## ADDENDUM NUMBER 2

Project Number **CMAQ 3319(412), City Project 70171305**

Project Title **I-35 and Chouteau Parkway  
Interchange Improvements**

ISSUE DATE: **11/12/2020**

## PLAN - NE CHOUTEAU PARKWAY

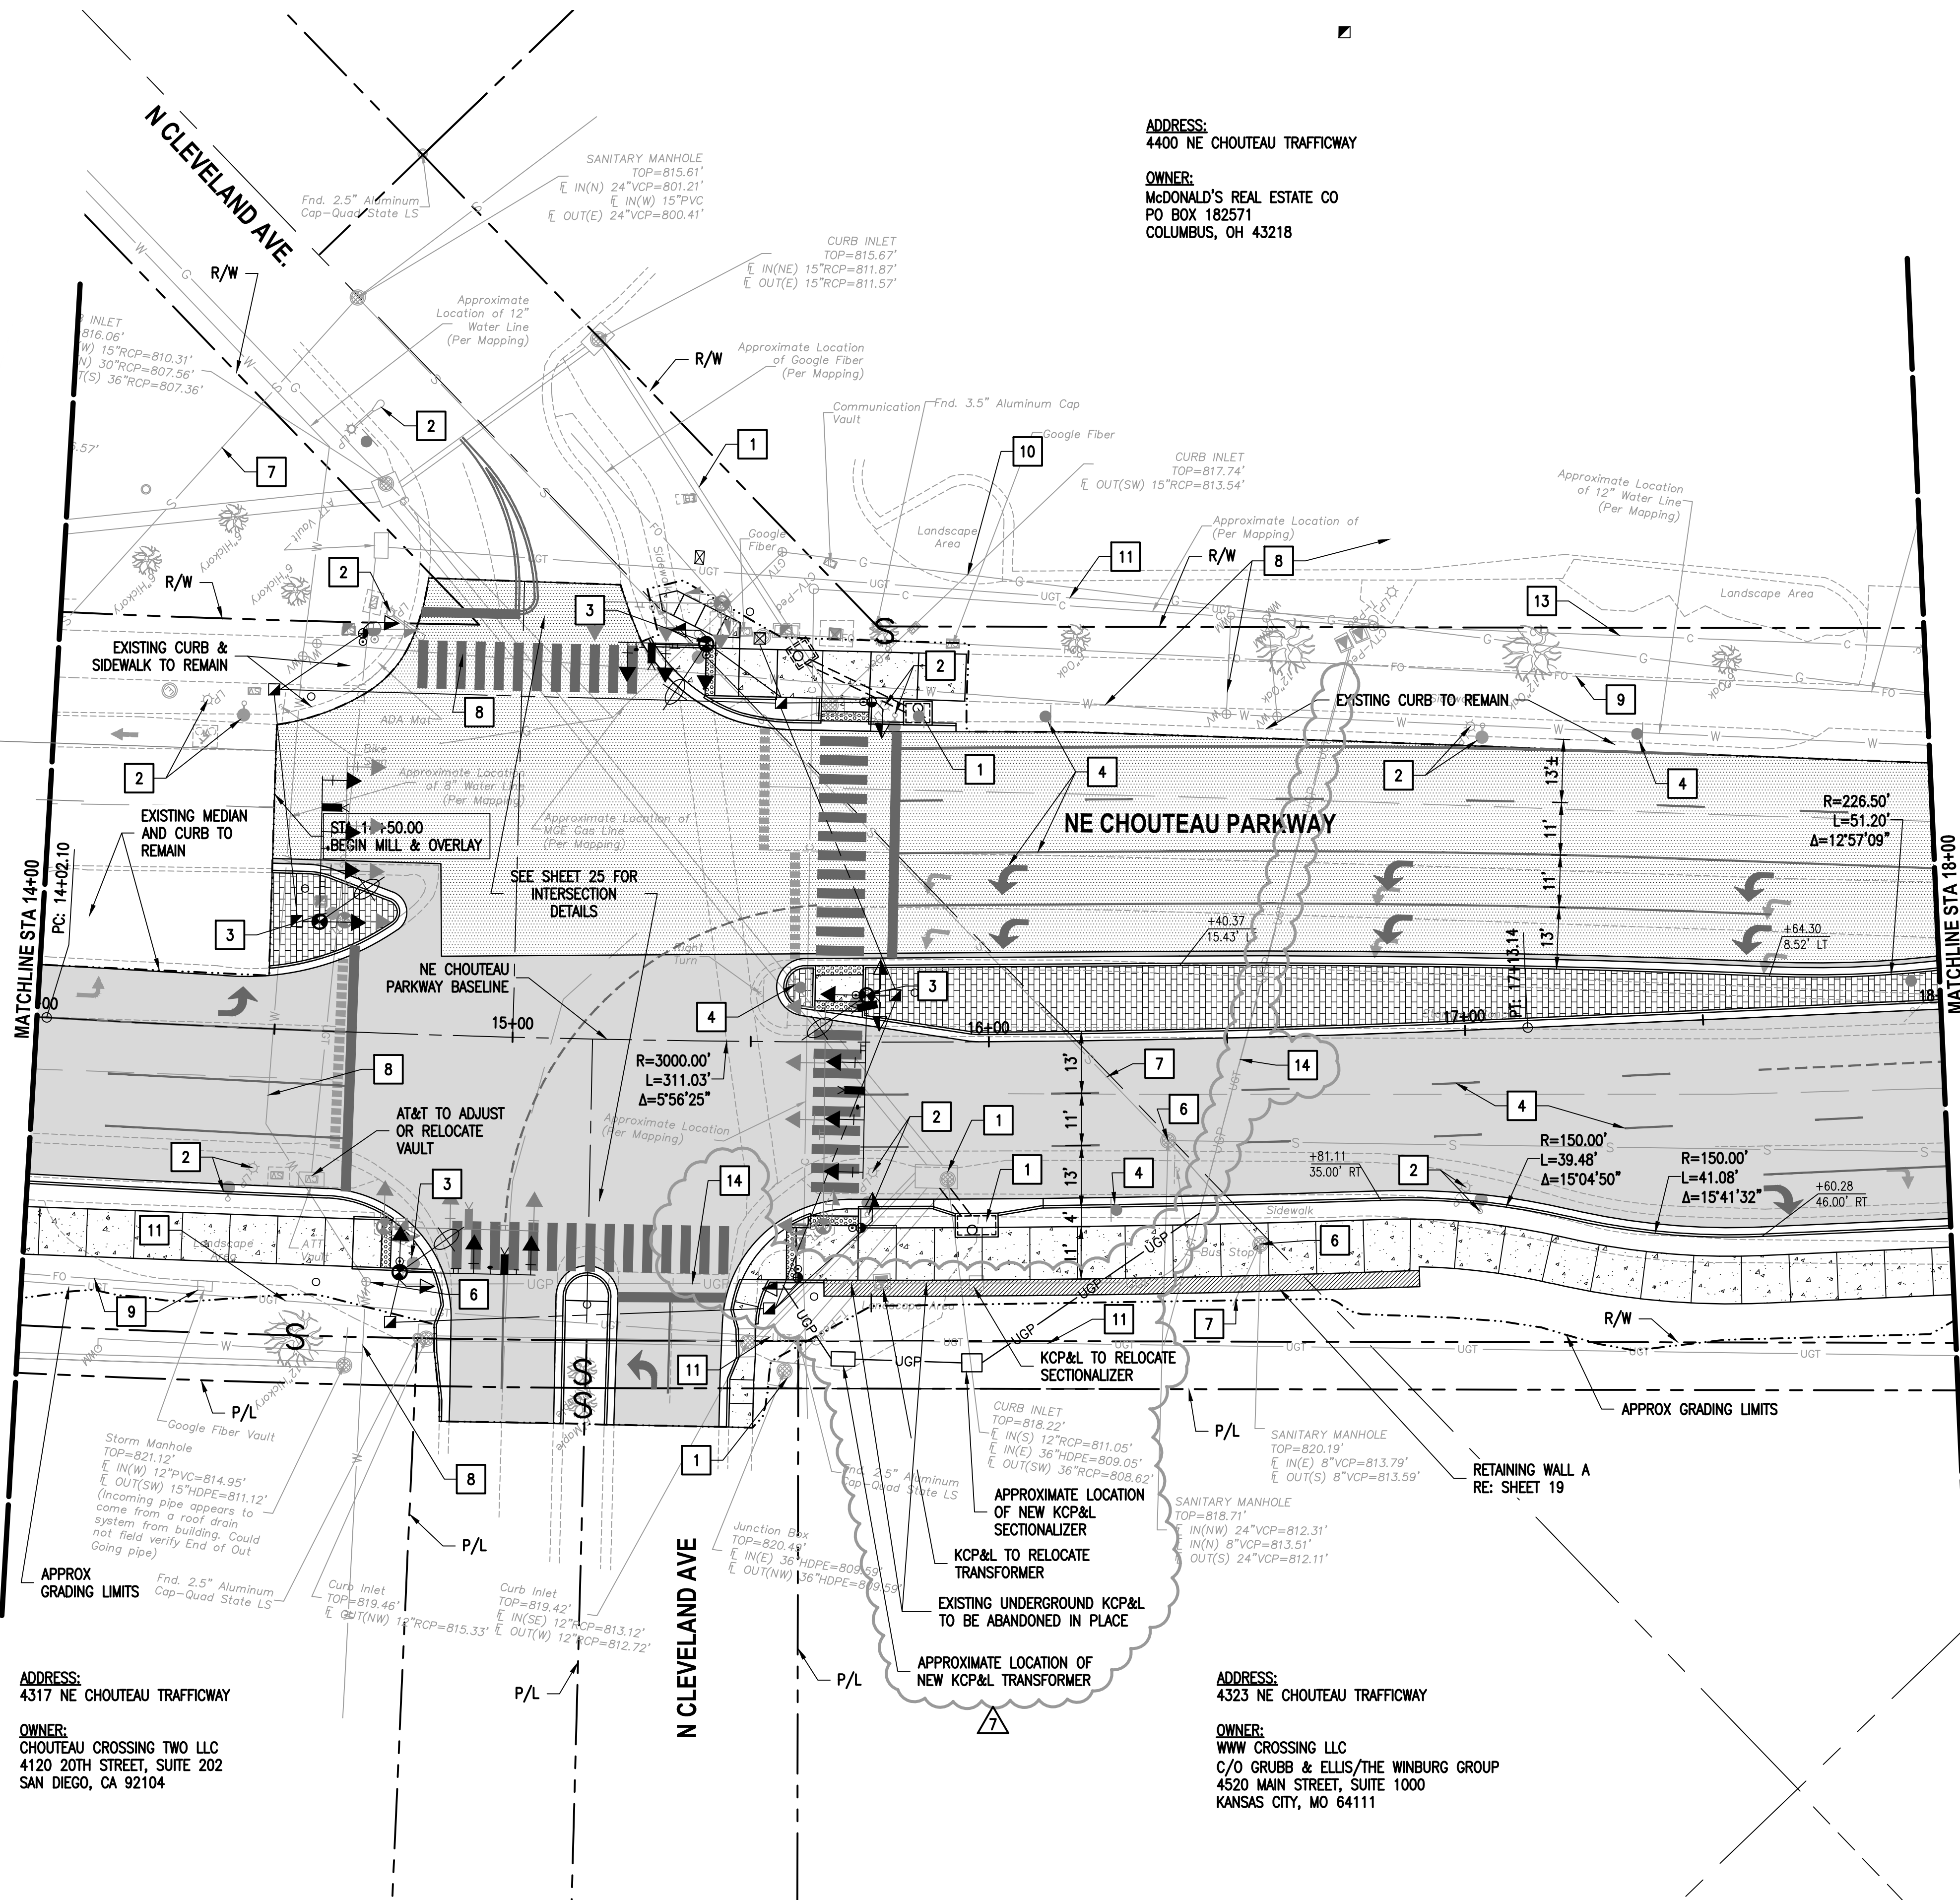
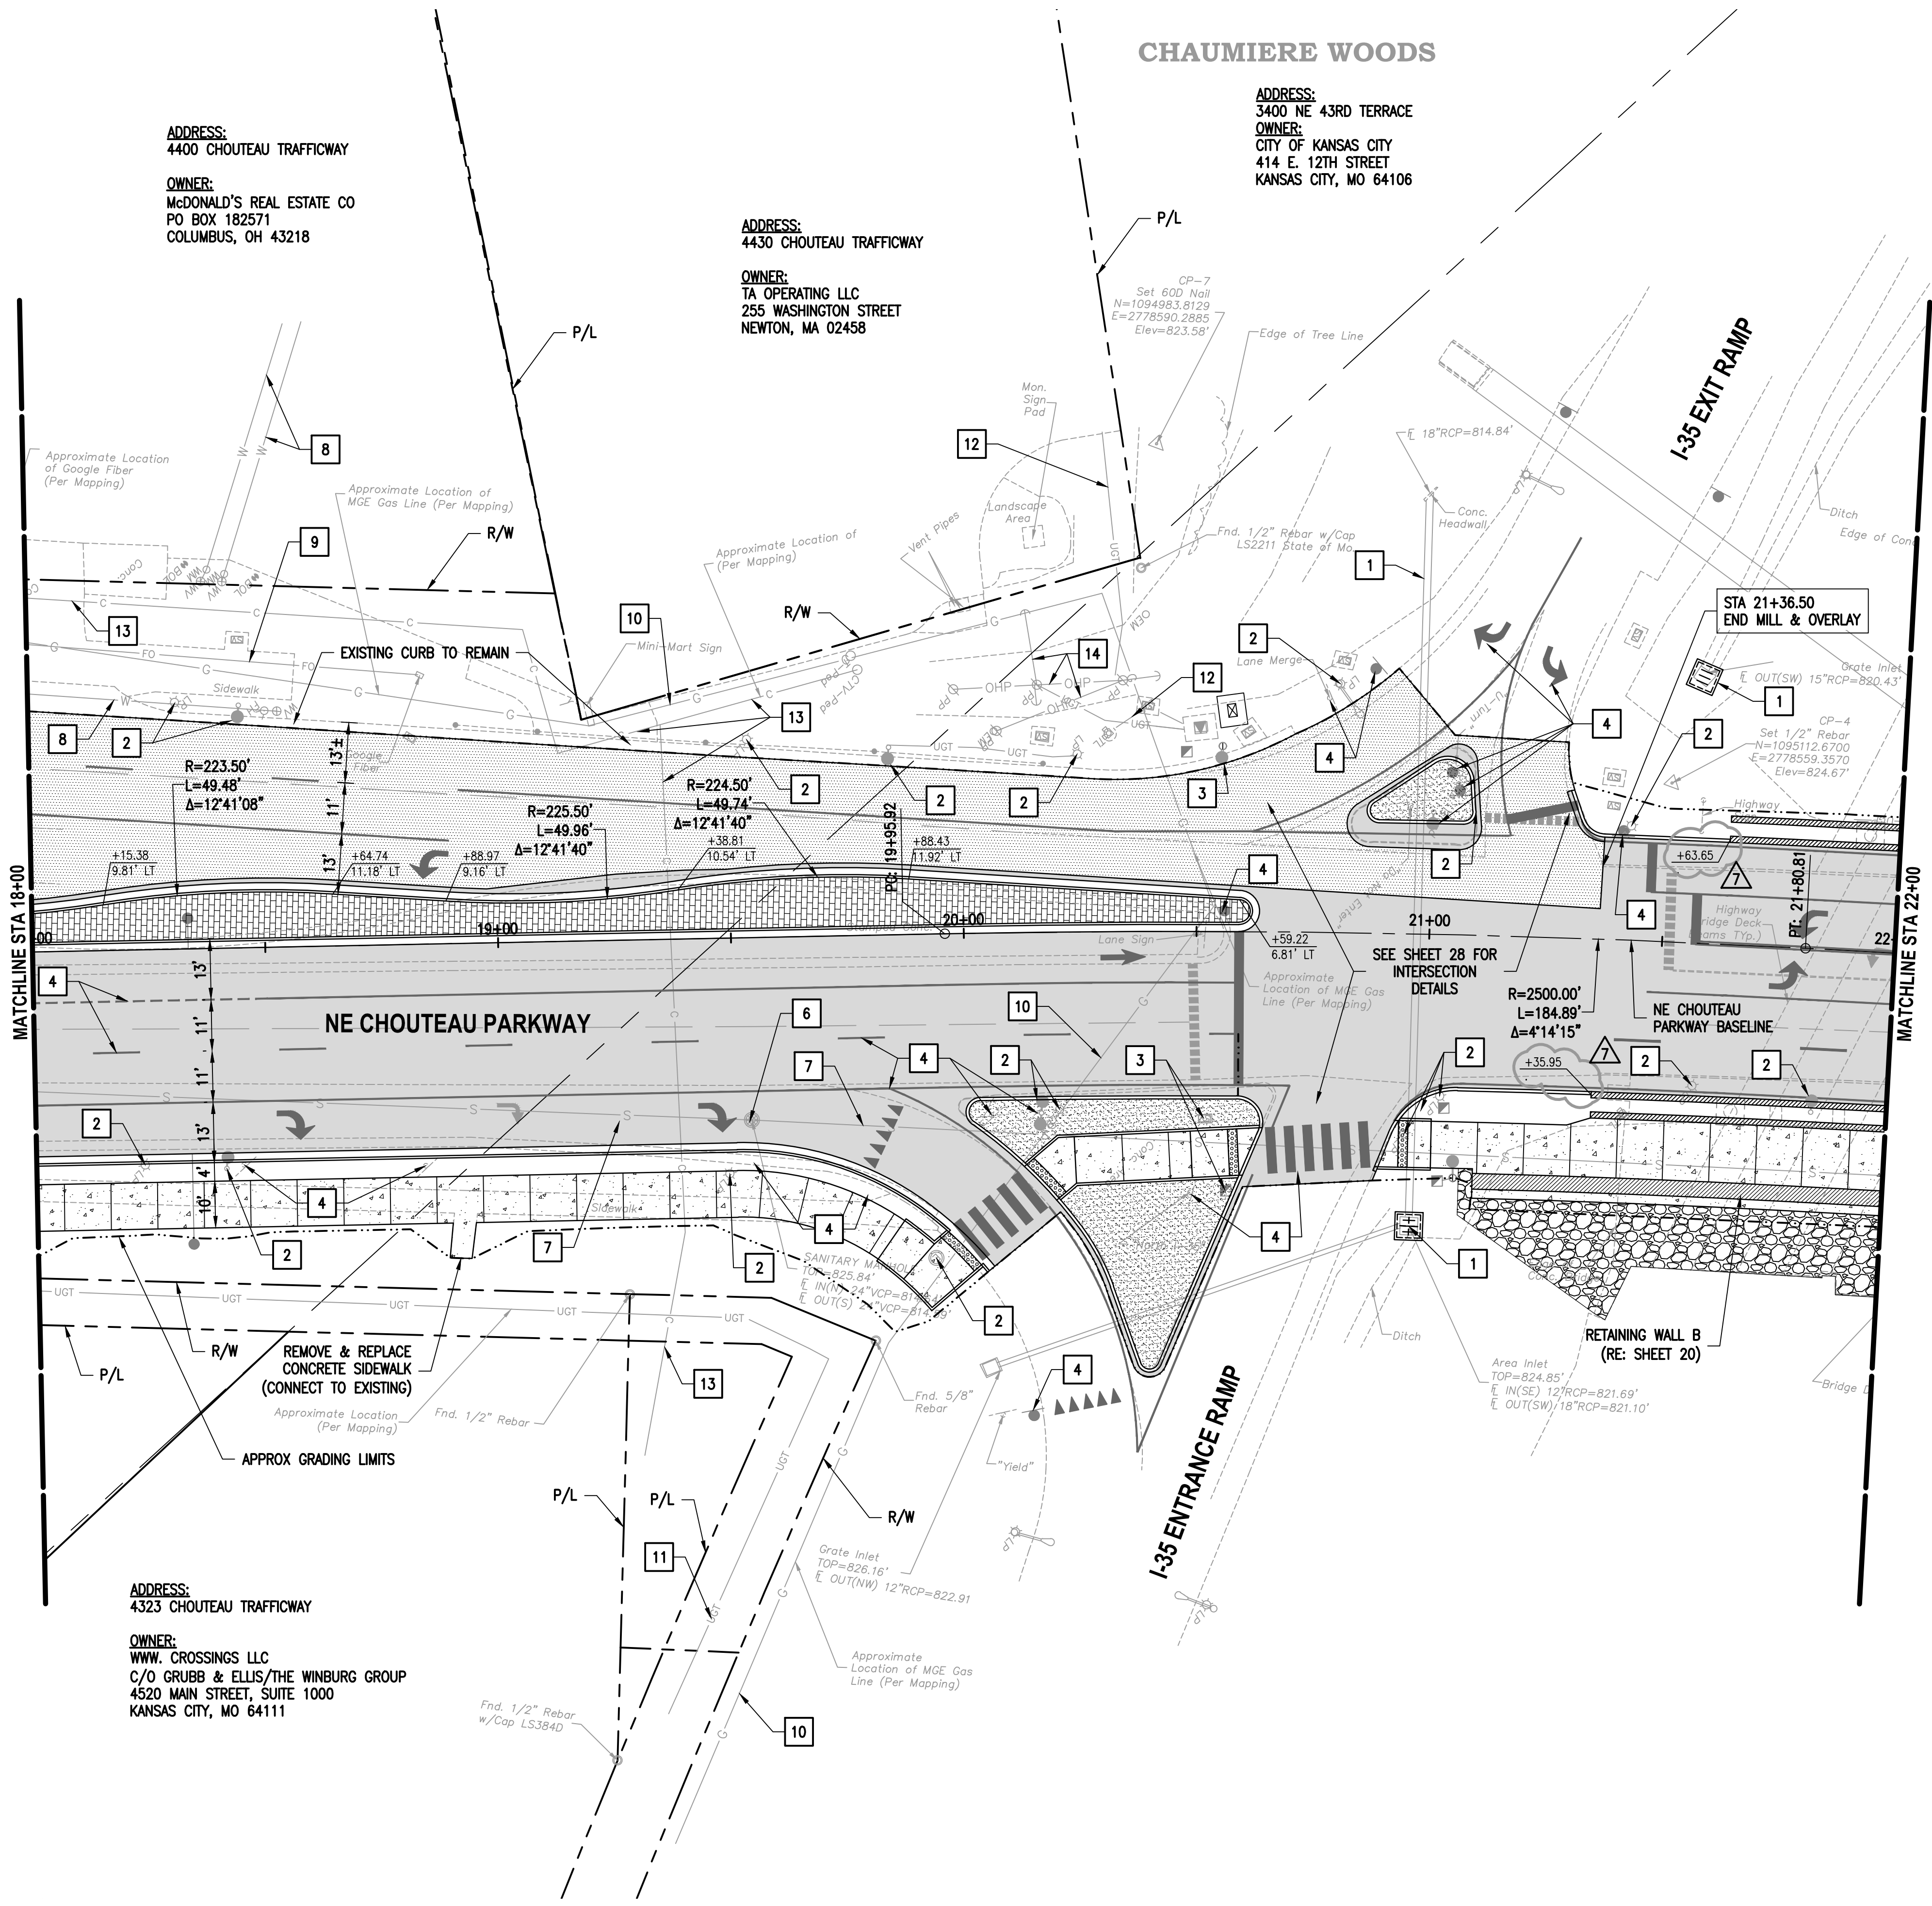
1. Agenda of the pre-bid conference meeting held on November 4, 2020 are provided.
2. Updated utility information related to existing and proposed Everygy systems are shown on sheet
